P802.3ad Draft 2.0 Working Group Ballot Comment Database, Revision 2.0. This document includes all comments submitted during the first WG Ballot, along with the resolution of each comment as determined during the September 1999 Interim Meeting in York.

Replace "Figure 43-13 – Selection Machine state diagram" with "Figure 43-13a – Mux Machine State Diagram (independent control)" and "Figure 43-13b – Mux Machine State Diagram (coupled control)" as shown below:

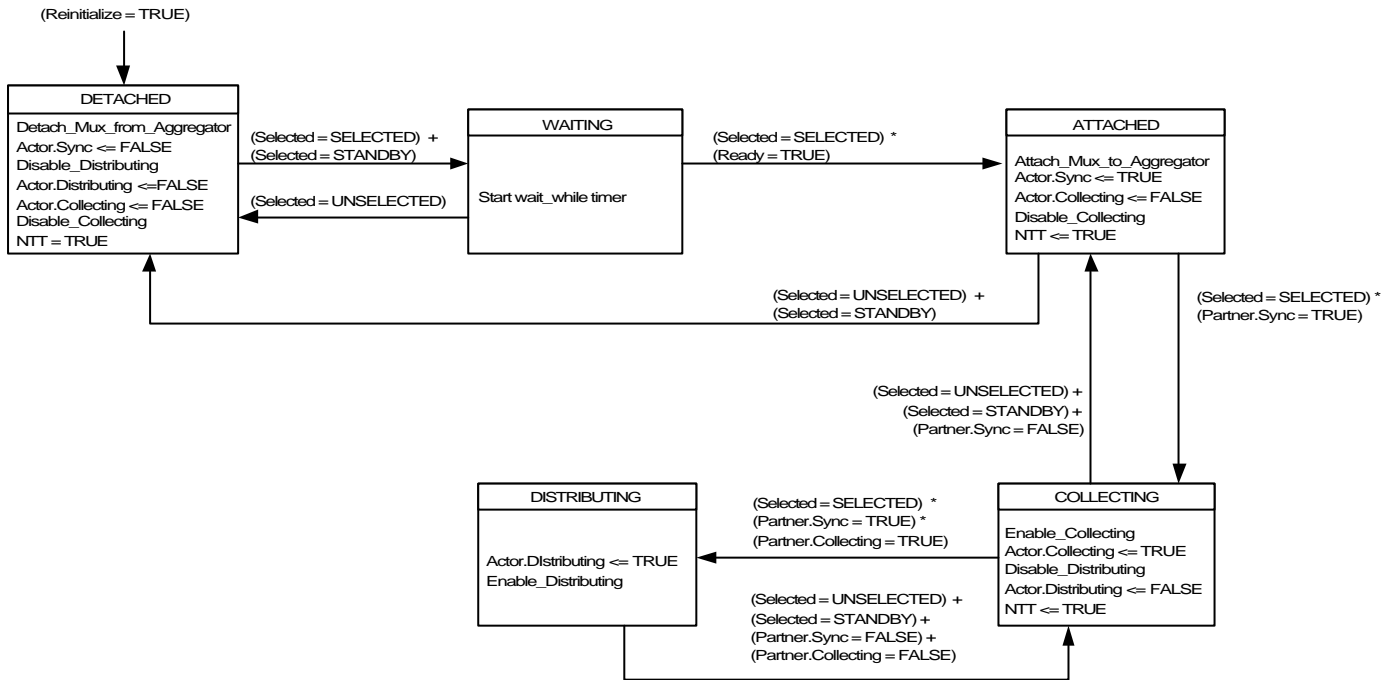
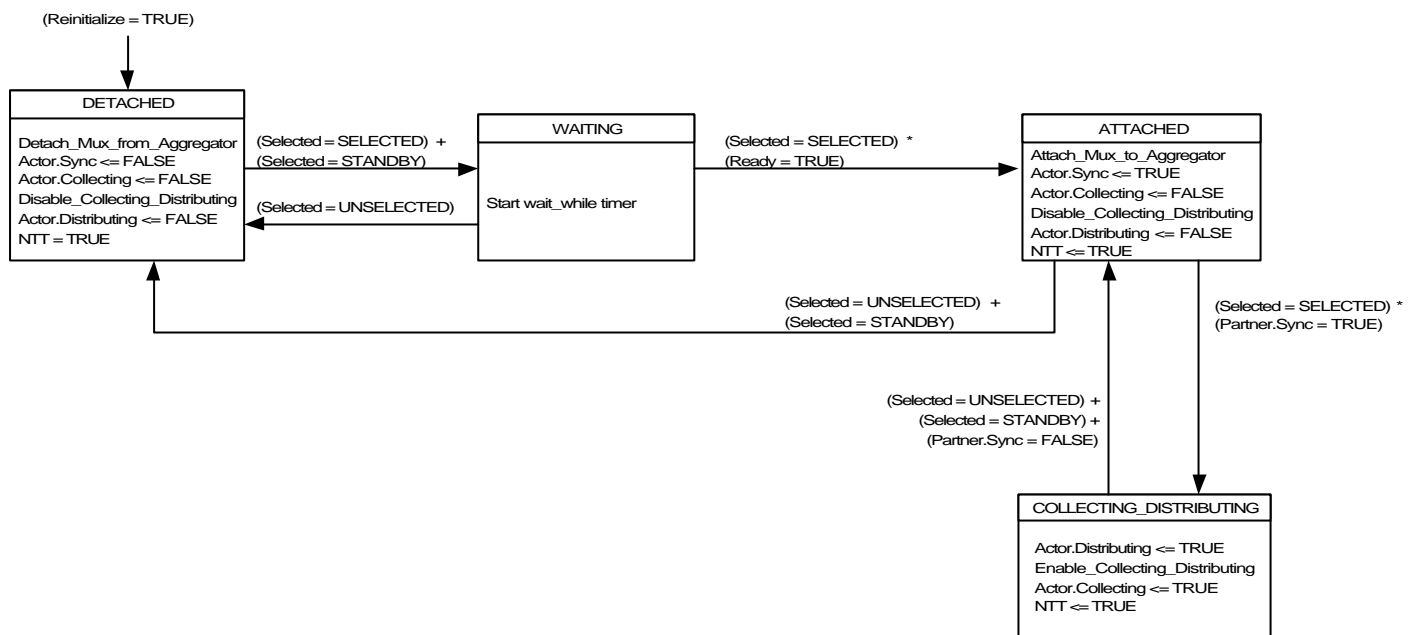
On page 142 lines 29-55, delete all text.

Accept in principle.
